**Re: Seacoast Reliability Project - SEC Docket 2015-04
Notification of Minor Construction-Related Changes**

SEACOAST RELIABILITY PROJECT

Table 1. Seacoast Reliability Project wetland impact changes due to construction modifications.

Revised Environmental Maps

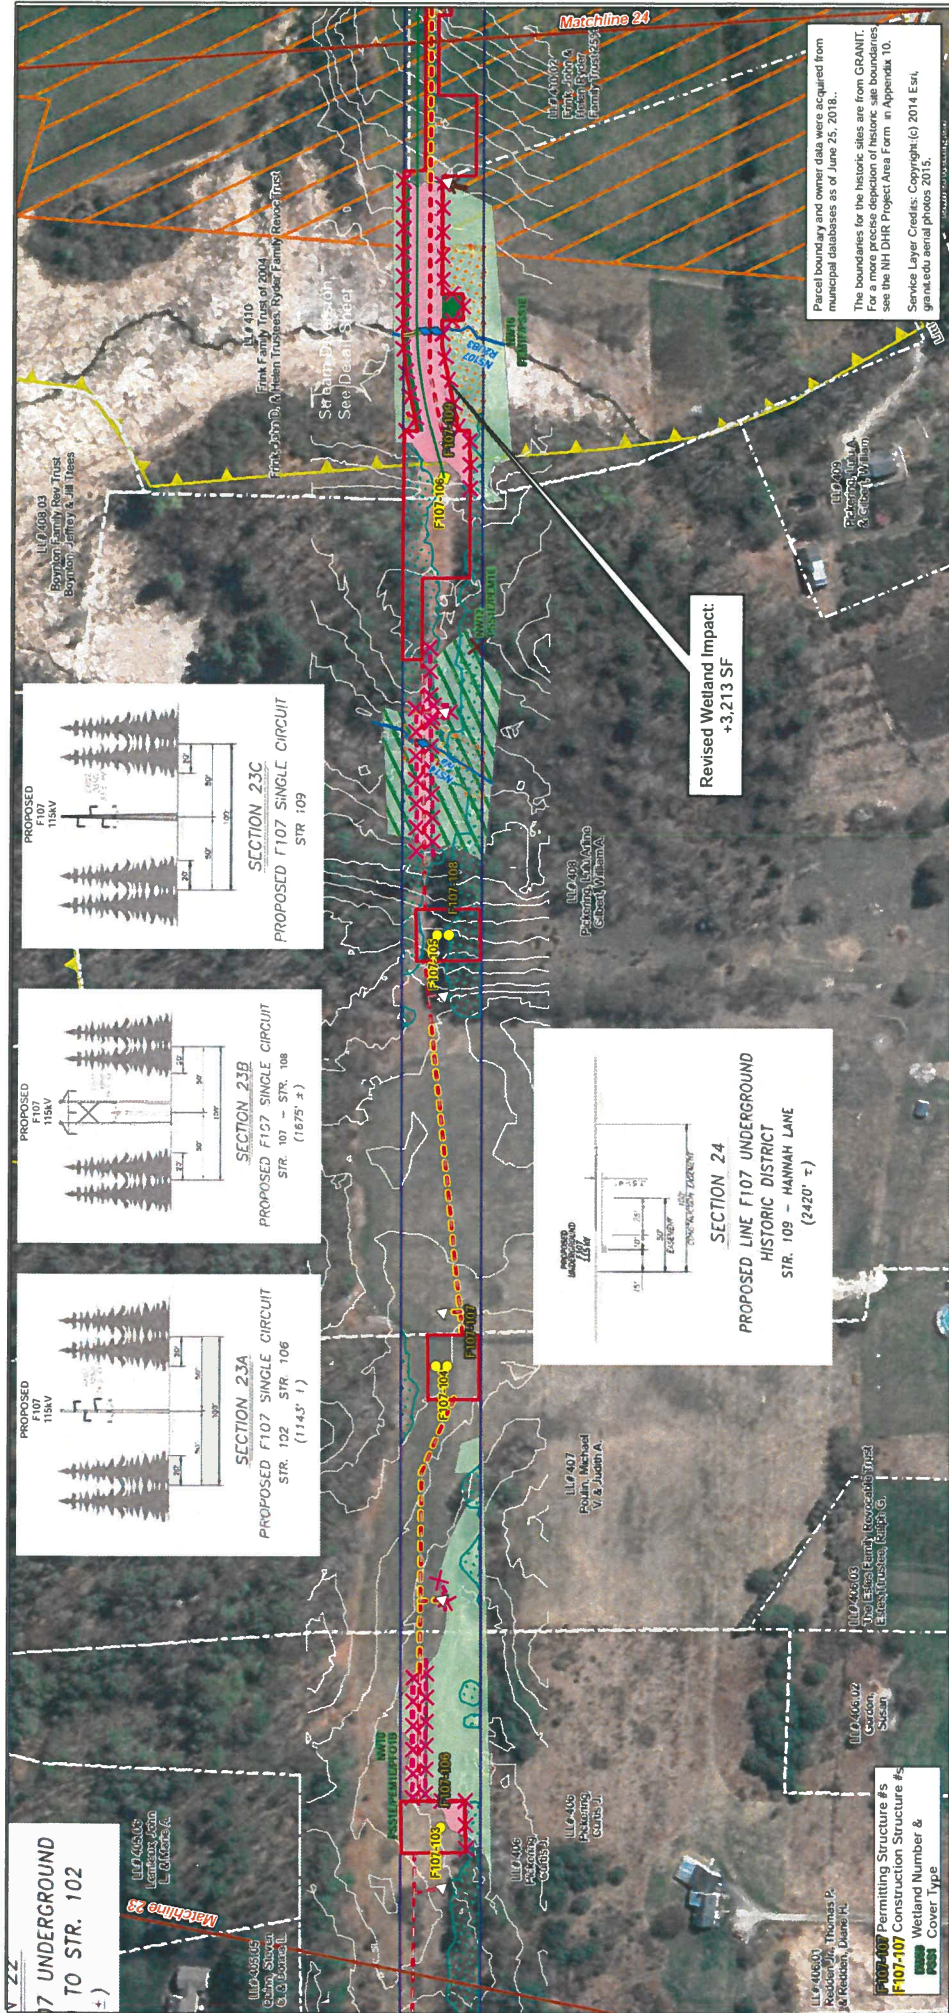
- Structure 81-82, Map 17. The contractors can avoid impacting Wetland DW 38 and a steep slope area by coming in from the east and the west. This change will result in a decrease of 4,014 sf of temporary wetland impact.

- Structure 85-86, Map 17. The contractors require a wider access road to accommodate pulling wire to Structure 85 and will not need to use all of a proposed work pad in wetland to the southeast, resulting in a net increase of 734 sf of temporary wetland impact to DW 24. The stone wall will either be bridged or dismantled.

Map 24 of 31

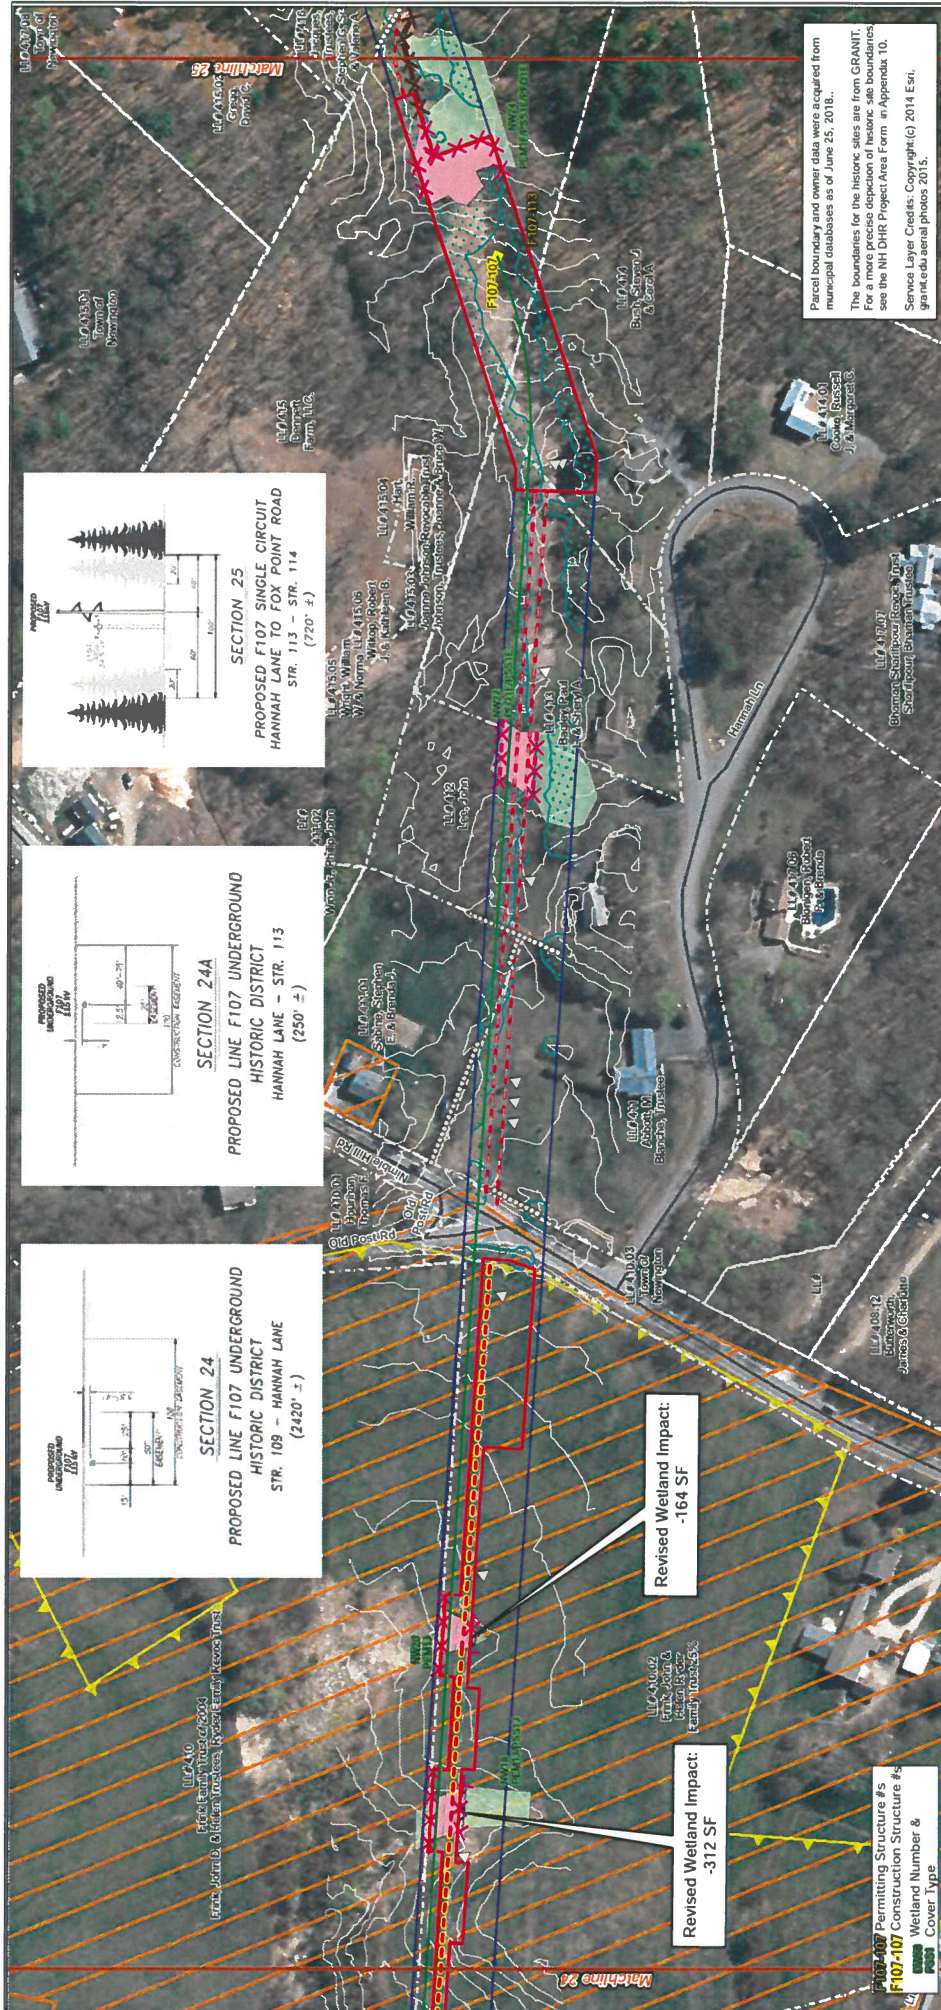
- Underground Section Between Structure 106 and 107, Map 24. In order to facilitate a proper and successful stream diversion for Knights Brook during trench excavation and duct bank installation, the contractors require a location to stage pumps and containment in close proximity and at similar elevation located within Wetland NW16. The stream diversion setup will be constructed using temporary timber mats with the pumps inside primary containment. These changes will result in a net increase of 3,213 sf of temporary wetland impact to NW 16.

Revised Wetland Impact:
 +3,213 SF

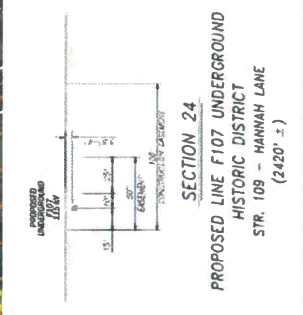
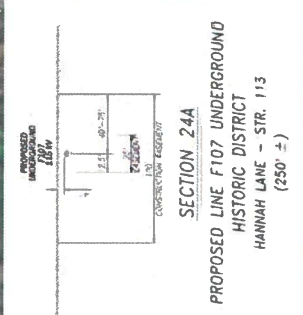
- Underground Section Between Structure 106 and 107, Map 24 and Map 25. As required by the Soil Management Plan for the Frink Farm, top soils from trench area are required to be replaced upon restoration. The top soils within the wetland areas will be temporarily wind-rowed up to the northerly edge of the easement. The soils will be piled onto of filter fabric placed over timber mats to reduce impacts to the wetland at the wind row location when the Contractor moves the top soil back into the trench during restoration. These changes will result in net decreases of 312 sf of temporary wetland impact to wetland NW 18 and 164 sf of temporary impact to wetland NW 20; the additional area of temporary impacts to wetland NW 16 due to soil management are included in the 3,213 sf described above.

Revised Wetland Impact:
-164 SF

Revised Wetland Impact:
-312 SF
